From: [Michael Stephenson](#)
To: [Akhter Hossain](#)
Cc: mkamal@kdheks.gov; [Jump, Christine](#); [SMITH, MARTIN L](#); [Brady Gerber](#); [Stuart Klaus](#)
Date: Wednesday, September 03, 2014 5:29:34 PM
Attachments: [Revised Figure 9.pdf](#)

FIGURE 9		
TOTAL EXTENT of ORGANIC COMPOUNDS EXCEEDING PRELIMINARY RAO (0 - 20ft) CLEAN HARBORS KANSAS, LLC		
SCALE:	AS SHOWN	PROJECT: 1808

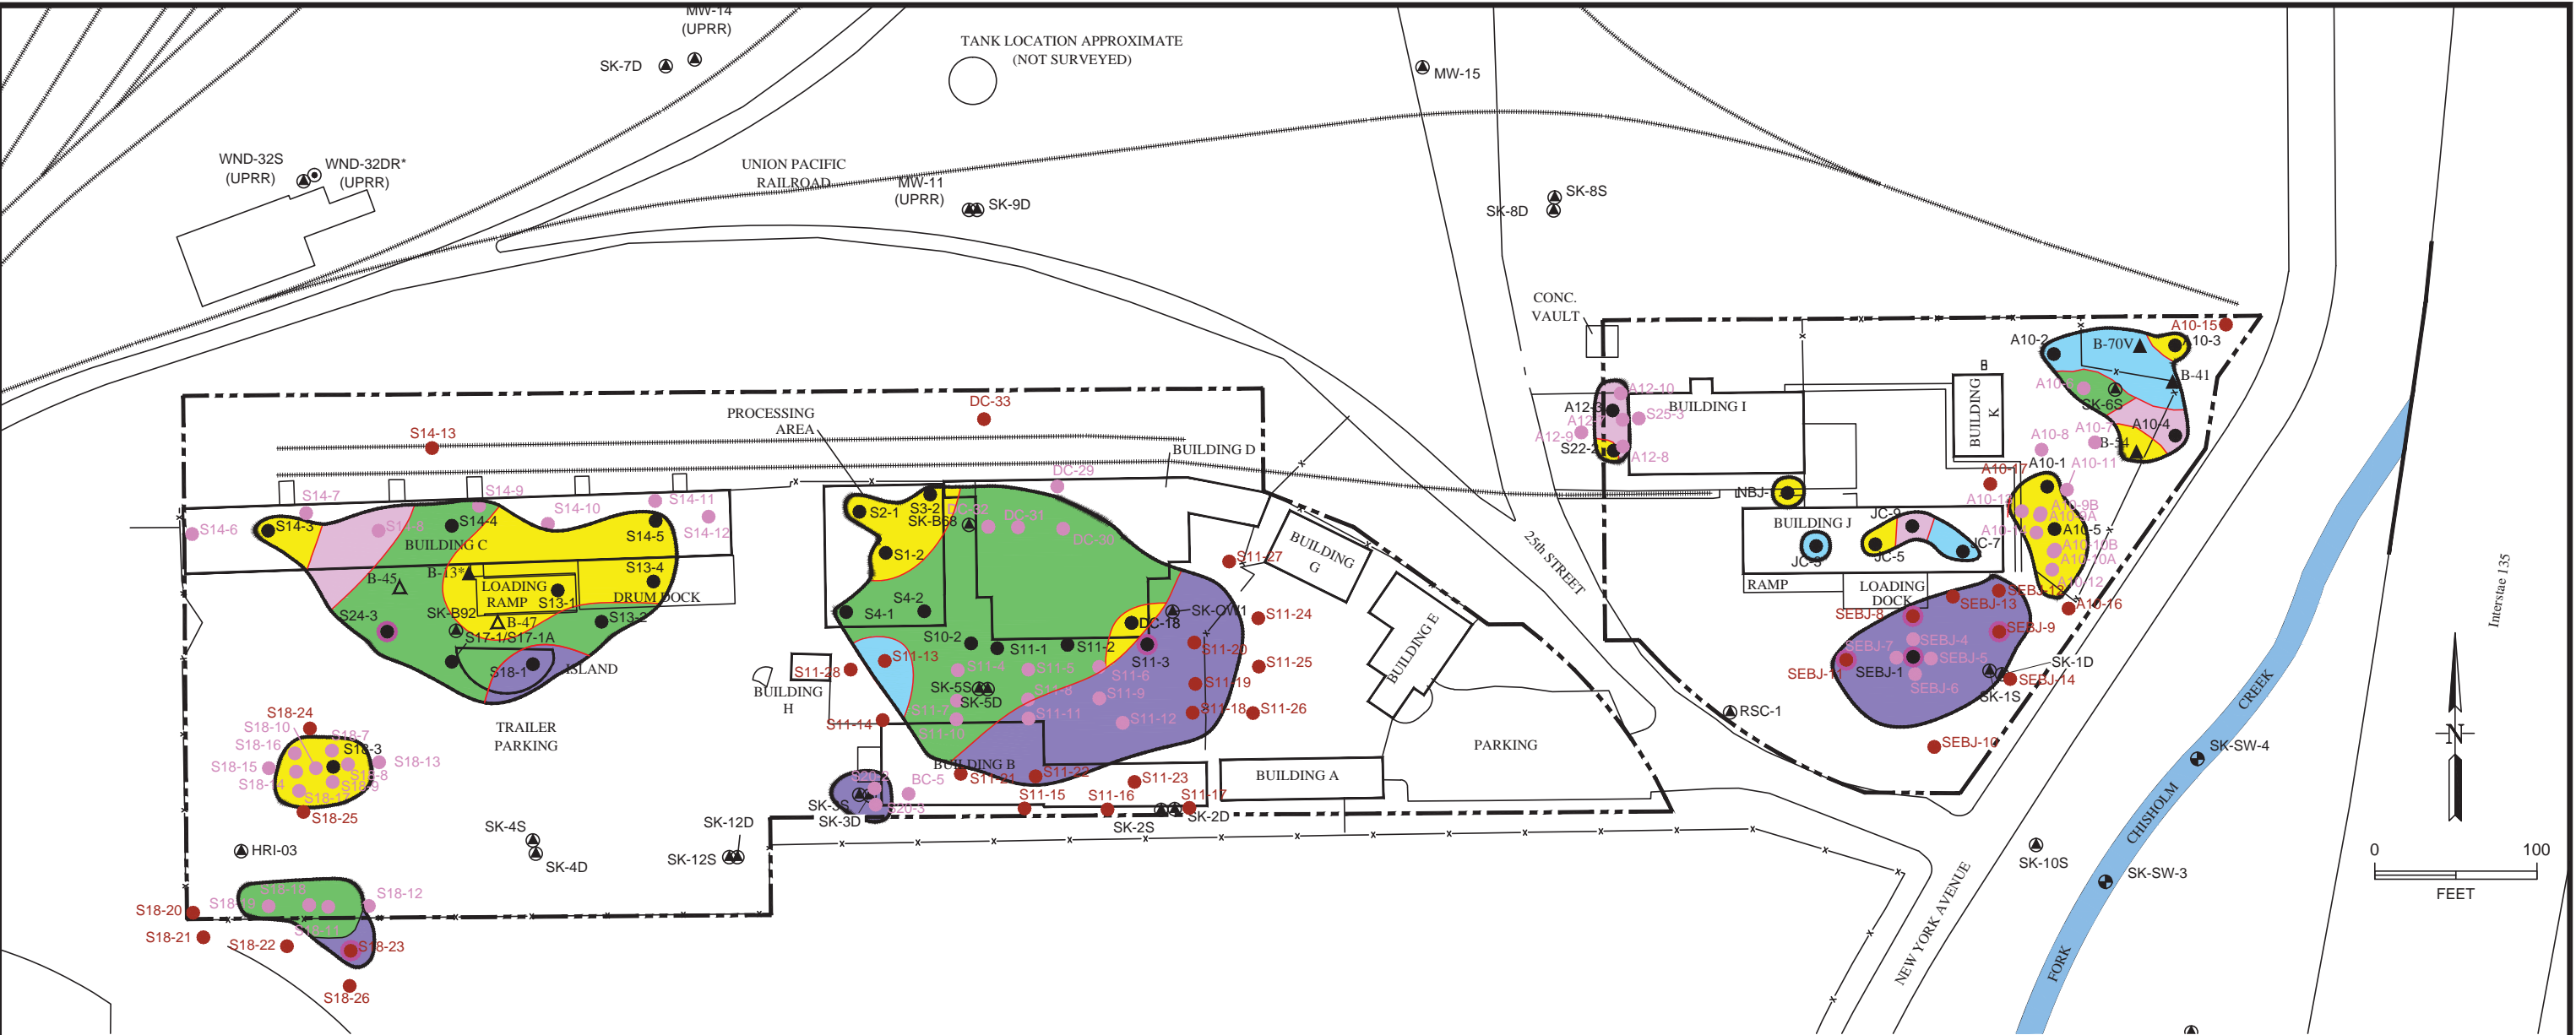
We are proceeding with the plan for concrete re-use as has been discussed with you and Mustafa on several occasions previously. Specifically, we are using the color coded map, Figure 9 (attached), to identify where soil/concrete interface samples will be taken in advance of removal of the overlying concrete. For Building B, four shallow soil samples will be collected along the light green line in the northern portion of the building to further delineate areas where the underside of the concrete may be impacted. In Building D, four soil samples will be advanced along the light green line in the northeastern portion of the building. In the processing area, four soil samples will be collected along the light green and yellow line in the western portion of the processing area.

If those samples show that the interface soils have concentrations of the VOC or SVOC constituents at levels meeting the RSK Tier II values then the overlying concrete can be used as backfill. Similarly, if samples come back over the limit then the concrete will be taken for off-site hazardous waste disposal. Also, if staining in any area under the concrete appears to be the result of spills reaching the sub-grade, such as where there was an overlying gap, then CHES will dispose of the concrete off-site.
